Rezoning Transportation Analysis

Petition Number: 2019-105

General Location Identifier: 02756118

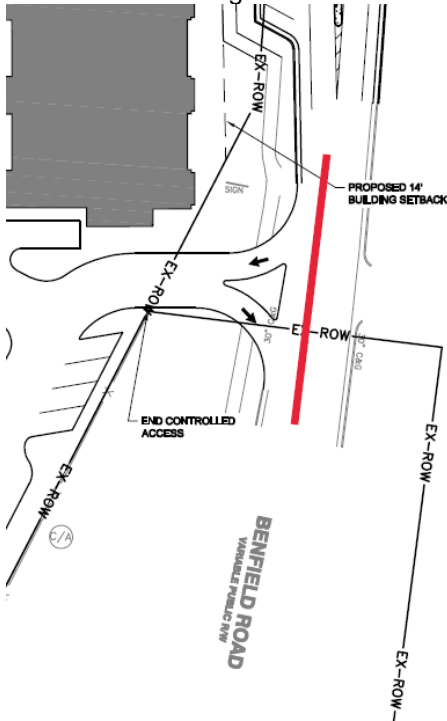
3. ~~The petitioner should revise the site plan and conditional note(s) to remove the reverse angled parking along Benefield Road and Summer Creek Lane.~~
4. ~~The petitioner should revise the site plan and conditional note(s) to show buffered bike lane along Benefield Road.~~ Comment Rescinded: Site plan no longer has on street parking, which no longer affects the existing bike lane. (Site Plan 10/14/19)

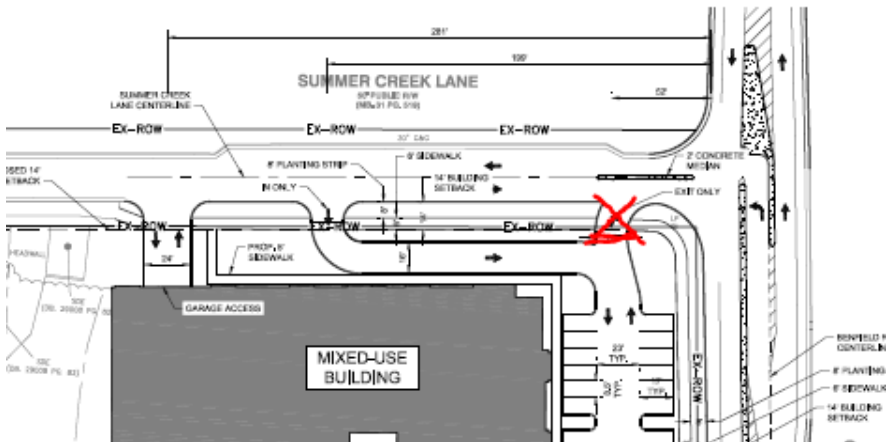
8. ~~New comment based on site plan (10/14/19):~~ The petitioner should revise the site plan and conditional notes to remove exit only driveway on Summer Creek Lane.

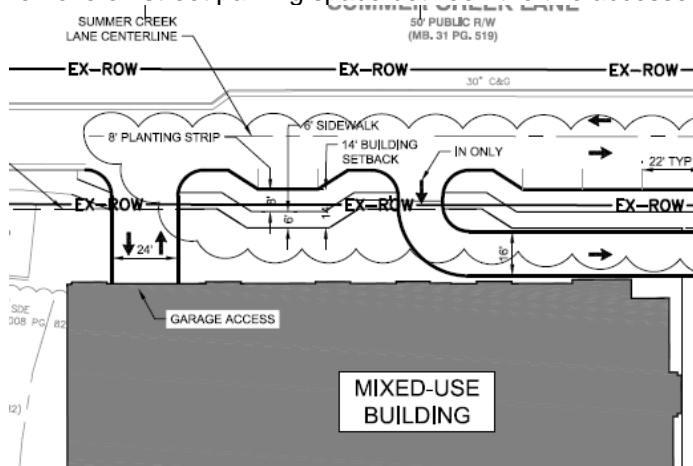
9. **New comment based on site plan (11/08/19):** The petitioner should update the site plan to show an ADA on street parking space on Summer Creek Lane.
10. **New comment based on site plan (11/08/19):** The petitioner should update the site plan to show remove on street parking space between the two accesses on Summer Creek Lane.
